Maxtor Corporation
500 McCarthy Boulevard
Milpitas, CA 95035 USA

To: T10 Serial Attached SCSI PHY Working Group
From: Russ Brown
Email: russ_brown@maxtor.com
Contact: Mark Evans
Email: mark_evans@maxtor.com
408-894-5310
Date: 02 November 2002

Subject: SAS driver and receiver electrical characteristics additions

Figure xxa. Transmitter transient test circuit

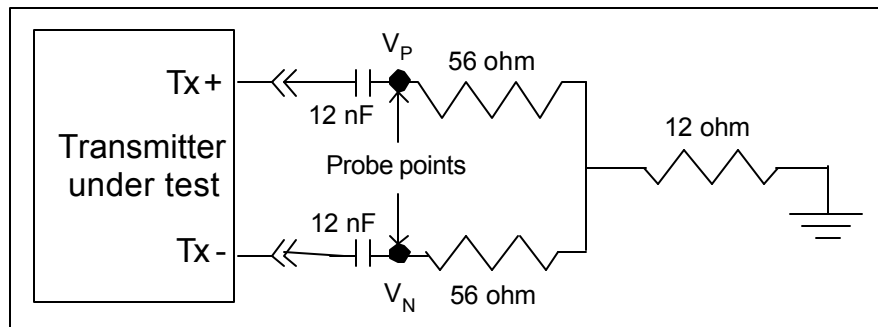
c The coupling capacitor value for AC coupled transmit and receive pairs.
 d The maximum transmitter and receiver transients are measured at nodes V_P and V_N on the test loads shown in figures xxa (for the transmitter) and xxb (for the receiver) during all power state and mode transitions. Test conditions shall include the system power supply ramping at the fastest possible power ramp (up and down).
 e Receivers must tolerate sinusoidal common mode noise components within the peak-to-peak amplitude (V_{cm}) and the frequency range (F_{cm}).

Add the following figures after the table:
